3/4.4.9 PRESSURE/TEMPERATURE LIMITS

ATTACHMENT 2

PROPOSED TECHNICAL SPECIFICATION CHANGE

UNIT 2

Figure 3.4.2 Reactor Coolant System Temperature-Pressure Heatup Limitations
Valid up to 10 EFPY

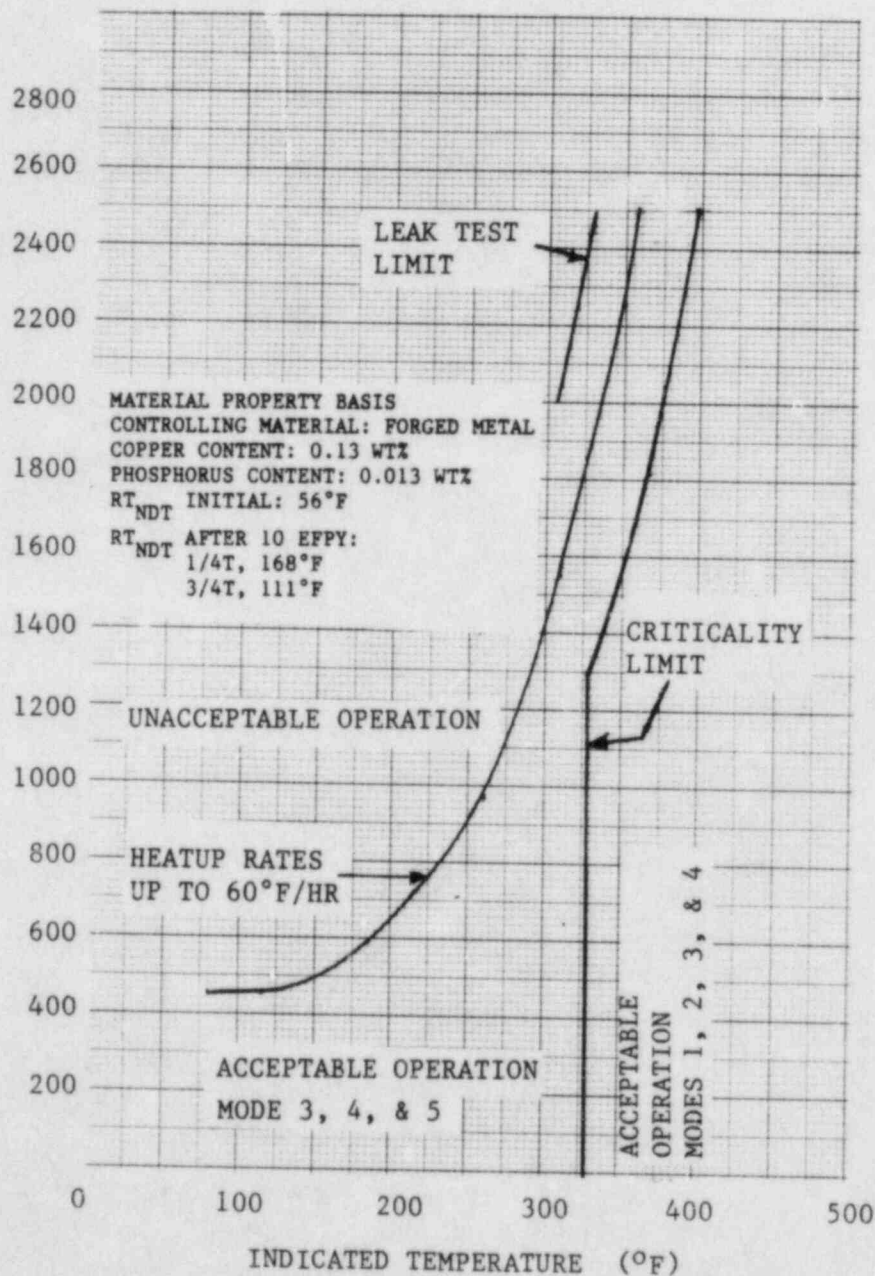
3.4.9.1 The Reactor Coolant System (except the pressurizer) temperature and pressure shall be limited in accordance with the limit lines shown on Figures 3.4-2 and 3.4-3 during heatup, cooldown, criticality, and inservice leak and hydrostatic testing with:

- a. A maximum heatup of 60°F in any one hour period.
- b. A maximum cooldown of 100°F in any one hour period.
- c. A maximum temperature change of less than or equal to 10°F in any one hour period during inservice hydrostatic and leak testing operations above the heatup and cooldown limit curves.
